Question	SCC response
1.	General		
3.1.2	Applicant and Surrey County Council (SCC)	<p>In your Statement of Common Ground (SoCG) [REP5-009] the Applicant refers to a schedule of works that are expected to become the responsibility of SCC in the future should the DCO be made. When is this schedule going to be provided to SCC? In addition, is SCC content with the two plans that the Applicant has provided and which are described in section 1.4.1 of [REP5-009]?</p>	<p>SCC are currently awaiting receipt from the Applicant of the schedule of works that are expected to become the responsibility of SCC in the future should the DCO be made. To assist the applicant SCC prepared and sent to the Applicant (on 14/02/20) a suggested draft table for use to determine the value of commuted sums to cover maintenance of additional items.</p> <p>This list was not exhaustive and needs to be added to as appropriate to clearly define the assets being considered but was provided to enable the Applicant to value the commuted sum payment. SCC were pleased to learn that the Applicant has been reviewing and assessing this table through its Commercial Team and SCC look forward to receiving confirmation of the a

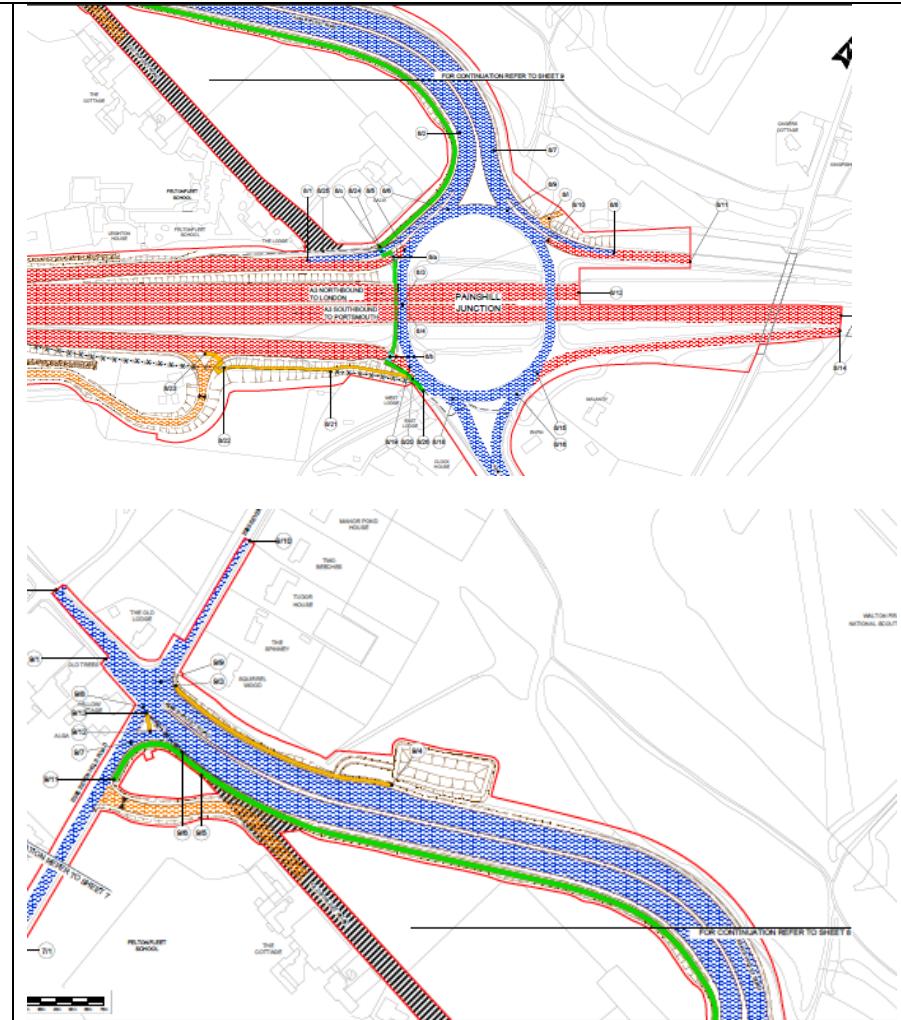
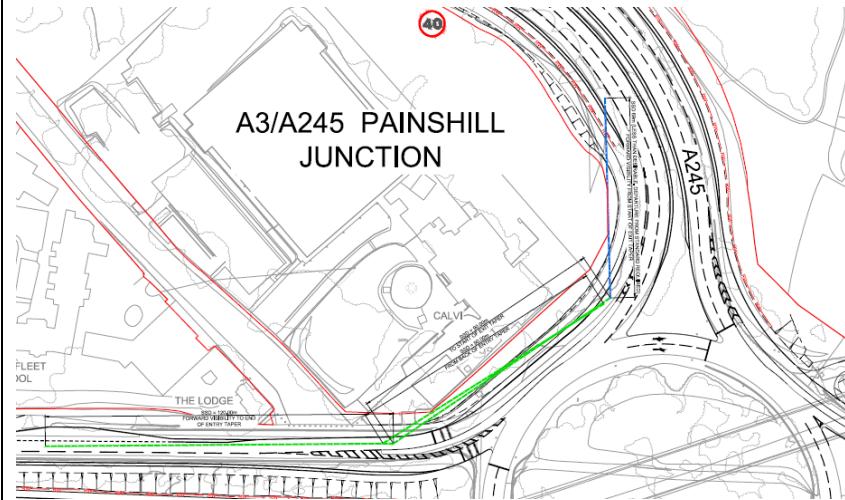
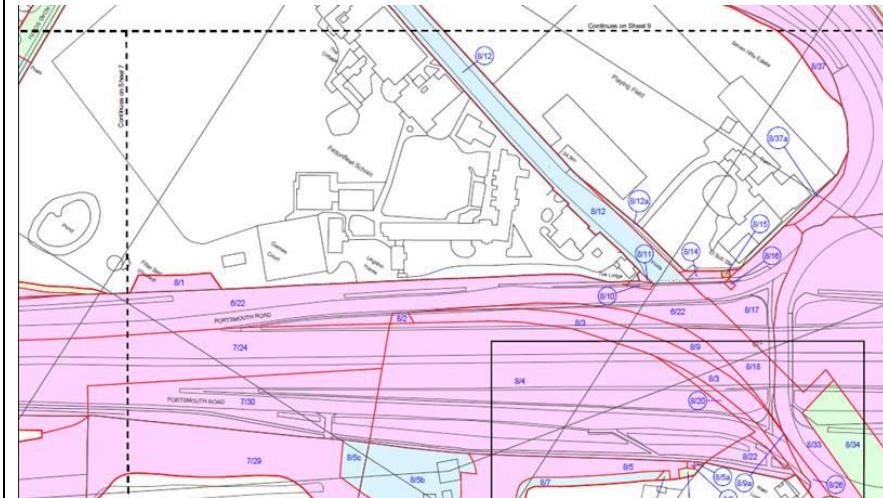
<p>Regulations 2015) who should demonstrate to the satisfaction of the future road owner (SCC) as to whether our future road meets design standards and is safe or not, and if not what the mitigation might be. This will allow SCC to decide whether the design is acceptable or not.</p> <p>To date SCC have not seen the Road Safety Audit or achievable visibility splays/forward visibility in many locations and whether they meet design standards or require a departure and associated mitigation.</p> <p>If the land that affects the forward visibility becomes Highways England, or unless they have rights over it to enter it and undertake necessary maintenance, and together with the network itself, becomes part of the SRN, the responsibility lies with LHA (eg SCC) – which is something SCC would not want to take on, as it's not us who's creating the departures.</p> <p>If additional land is required to achieve forward visibility requirements for the local road network then SCC will require to have the title of the land to enter it and undertake necessary maintenance.</p> <p>If there is any vegetation within visibility splays that will require removal and hence ongoing maintenance that would in future fall to SCC then SCC will require the relevant commuted sum payments from the applicant to remove the additional financial burden on SCC.</p> <p><u>A3 northbound off slip to the A245 westbound, as shown on drawing XX-SK-CH-000037 Revision C01</u></p> <p>The visibility “lines” shown on drawing XX-SK-CH-000037 Revision C01 are singles lines and not a visibility envelope as</p>

vehicles travel from A3 northbound off slip to the A245 and so SCC believe that to achieve the visibility splay shown will impact upon land outside of the highway boundary and mature trees in both highway ownership and possibly outside.

The applicant/Highways England are showing this area of land (plot 6/22 and other plots around the A3-A245 boundary) as title acquisition in this area and but is shown in the Book of Reference as Highways England already owning title.

The key issue at this location is that when considering the visibility envelope it would be the owner of the land required for the forward visibility for the two slips that's needed to be included within the DCO red line boundary but is not.

From consideration of the Book of Reference Plot 6/22 and other plots around the A3-A245 boundary e.g. plot 8/10, 8/11, 8/14, 8/16 are within Highways England ownership. But other plots are not e.g. 8/15 SE power networks, 8/37, 8/37a Feltonfleet school and there are plots outside of the red line boundary affected by the required visibility envelope that look to be outside of the highway

boundary e.g. owned by Felton Fleet school in the case of the off slip (westbound into A245).

New drainage pond access junction with the A245 eastbound , as shown on drawing XX-SK-CH-000039 Revision C01,

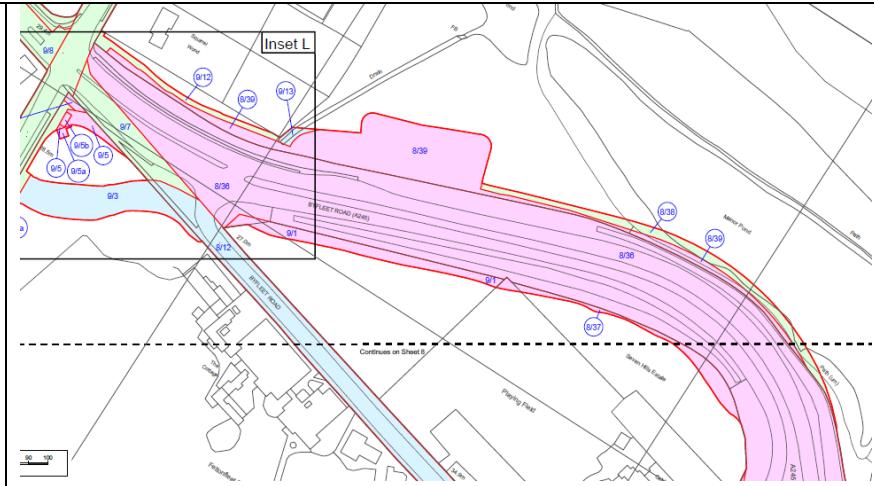
Considering the new drainage pond access junction with the A245 eastbound, the forward visibility as shown on drawing XX-SK-CH-000039 Revision C01 would appear to be acceptable and it is believed can all be contained within highway, given its location on the outside of the bend.

Visibility splays for vehicles exiting the junction should be shown however so that vehicles exiting the drainage pond access can see any queuing vehicles queuing back from the Painshill junction along the A245 and are not obscured by buses waiting at the bus stop. This may impact upon plot 8/39 which again is shown as title acquisition in this area and referring to the Book of Reference is

<p>currently owned by Burhill Developments and so not currently under highway ownership. There may also appear to be an impact on plot 9/13 which is shown in the Book of Reference as owned by Felton Fleet school. SCC would ask for clarity from the Applicant regarding these areas.</p> <p>SCC requested the Road Safety Audit in this location and previously raised this with the applicant, (see SCC's response dated 7th May 2019 to Pre-Application Consultation – Additional Non-Statutory Targeted Consultation). The access is "square onto the A245 and so would require a vehicle to perhaps stop on the A245 to make the turn. SCC's response at that time was as follows:</p> <p>"SCC note that an access road to the pond is shown but would ask has this arrangement had a Road Safety Audit (RSA) and if so a copy of this RSA could be provided to SCC, with the relevant section of the RSA indicated, to show how vehicles can safely access this pond from the A245 to avoid such risks as rear shunts? Also is the access road to be gated and if so would the location of this gate allow safe access/egress and avoid such issues as fly tipping?"</p> <p>The applicant (Highways England) submitted a Road Safety Audit late on the 9th April 2020 (Document Ref: HE551522-ATK-GEN-XX-RP-CH-000009). This road safety audit only covers two issues (both related to the Pond access junction with A245, east of junction with Seven Hills Road). The two actions are:</p> <ol style="list-style-type: none"> 1. A formal access junction or vehicle crossover can and will be provided during detailed design stage. The addition of formal access junction or vehicle crossover will reduce the risks of conflicts and collisions – SCC accepts that addressing this in the detailed design is possible

2. A turning facility can and will be provided during the detailed design stage. The provision of a turning facility within the pond area will eliminate the risks of collisions involving reversing vehicles - it is not clear to SCC whether this turning facility can be provided within the red line boundary and so SCC ask that this be clarified
